## **ADDENDUM NO. 1**

### **GARLOCK ROAD DELAMETER CREEK FISH PASSAGE PROJECT**

**Project No. 1779**

For the Department of Public Works, Cowlitz County, Washington

**GARLOCK ROAD - DELAMETER CREEK  
 FISH PASSAGE PROJECT  
 ROADWAY PLAN**

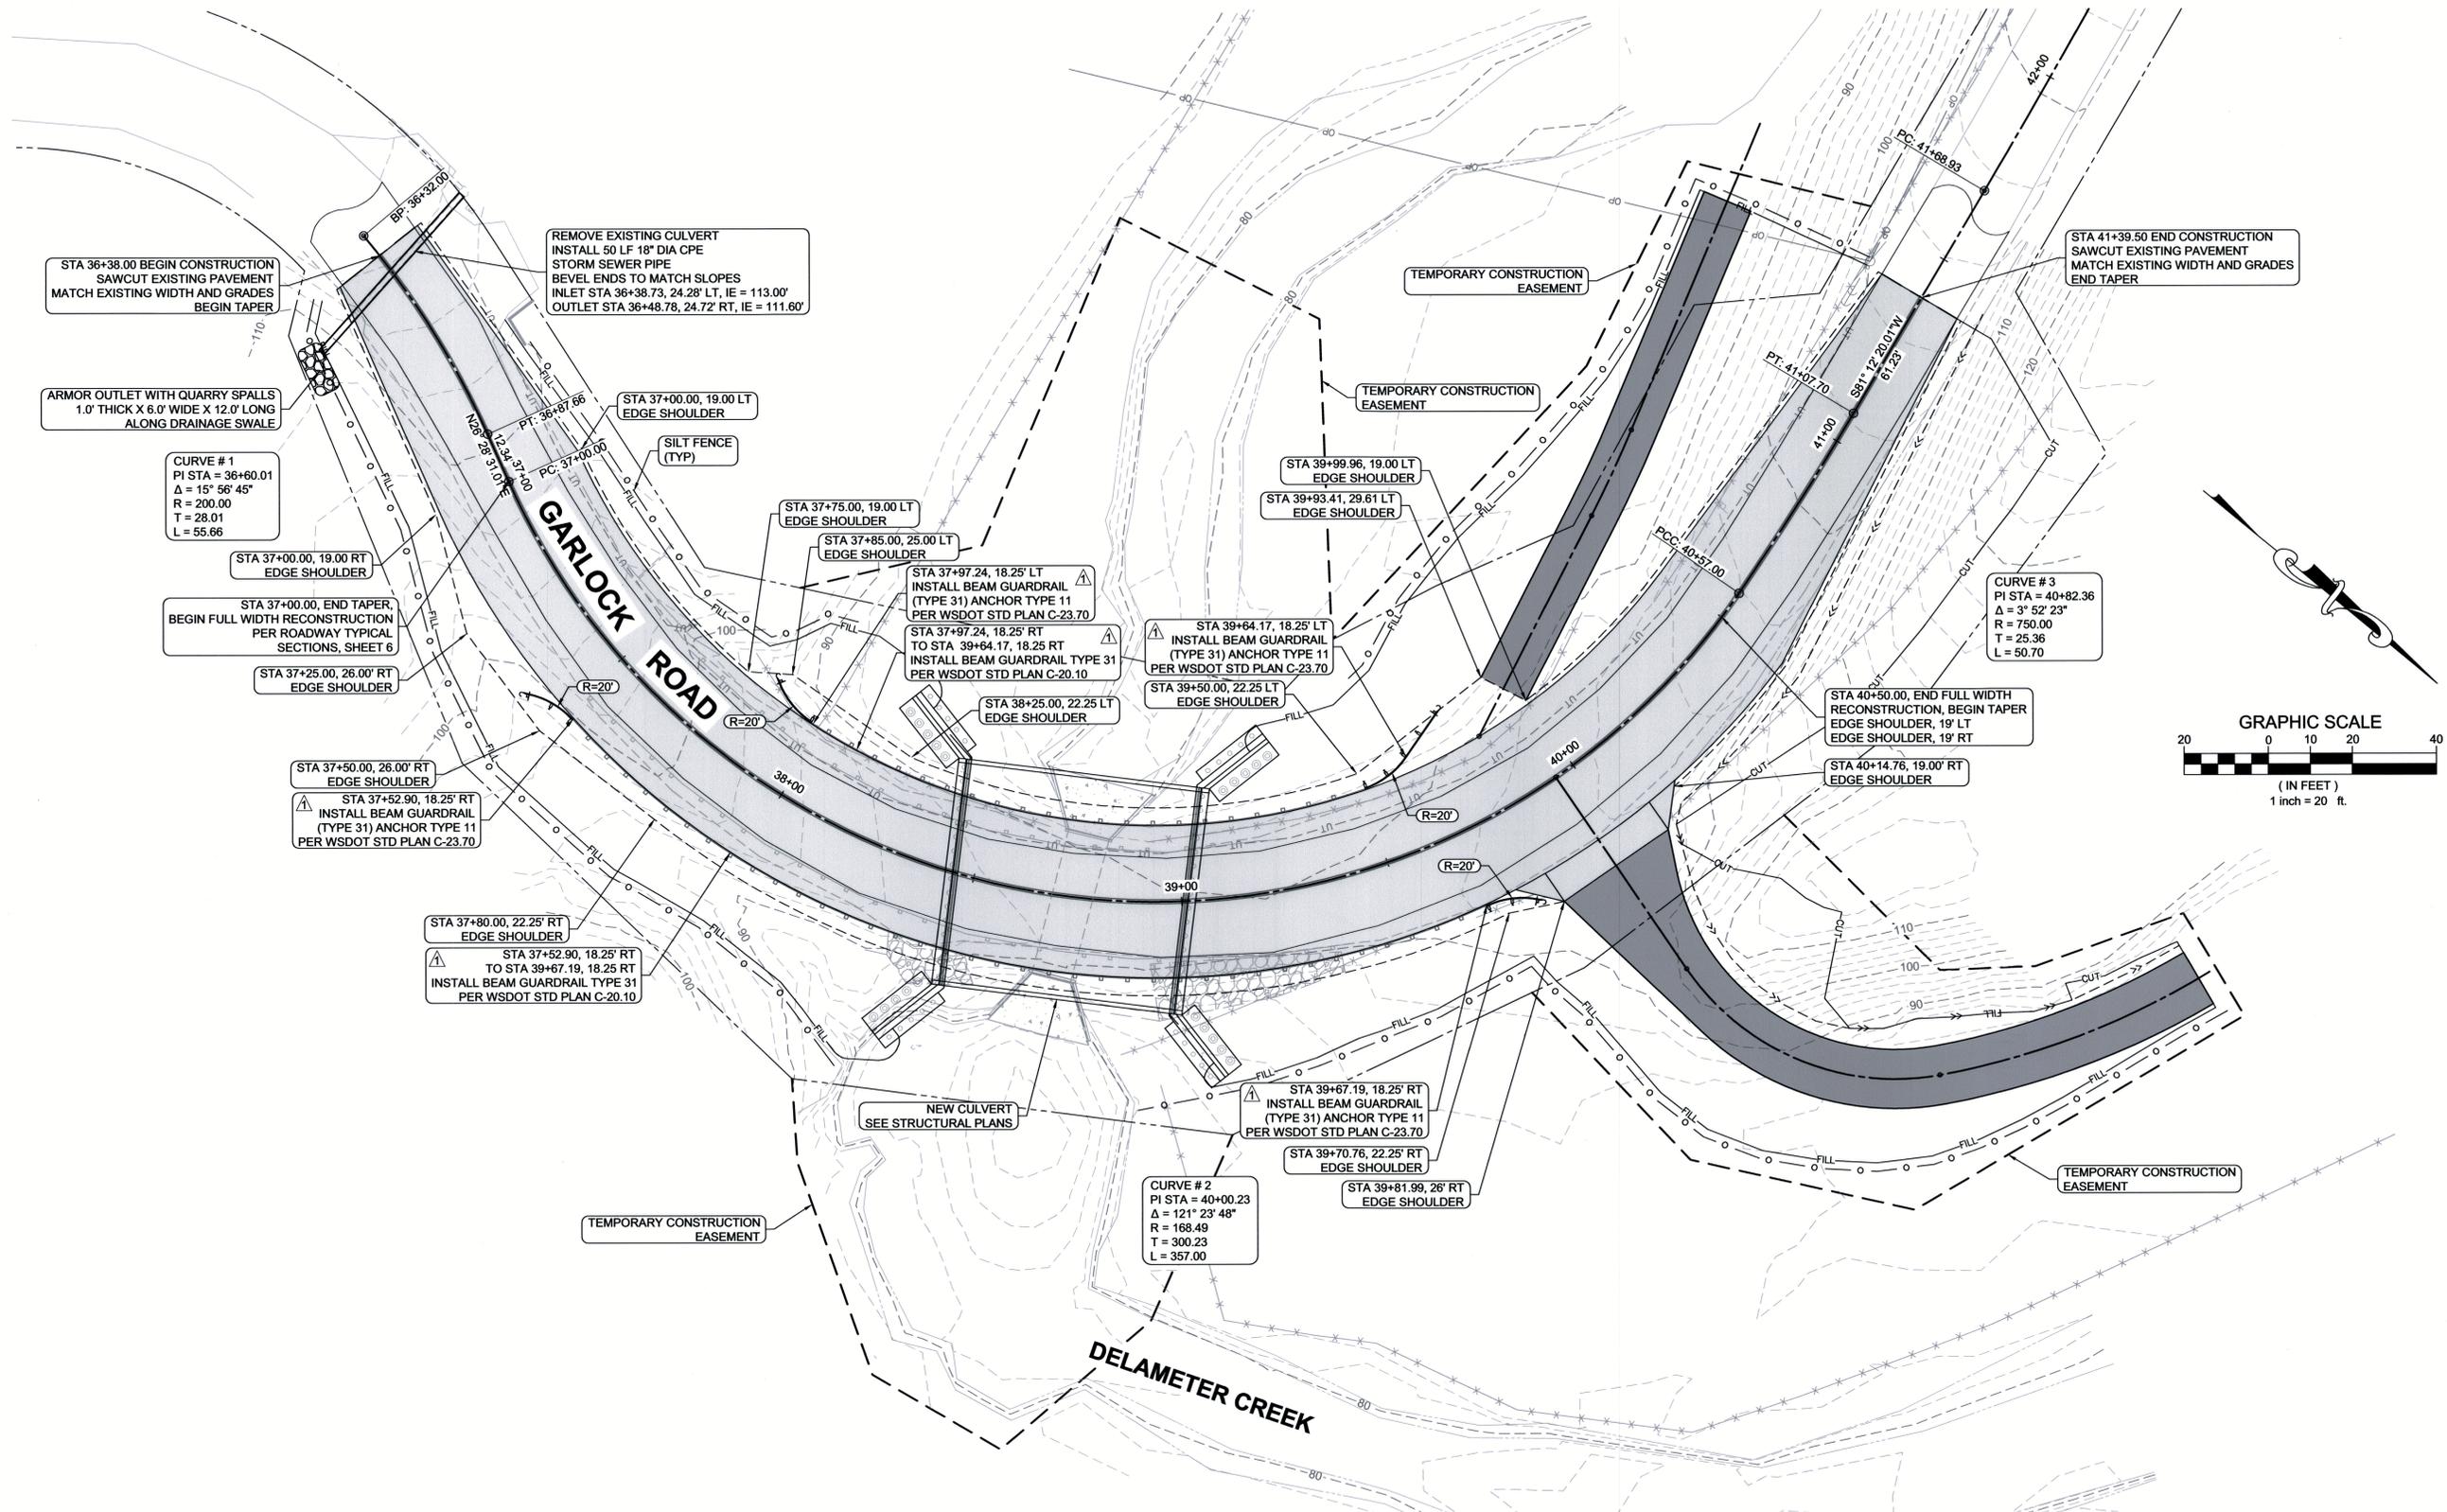
Revisions are made to the beam guardrail as shown on the revised sheet 3. Included in these revisions is the increase in the radius of some beam guardrail from 10 feet to 20 feet.

▲ GUARDRAIL REVISIONS 4/8/25
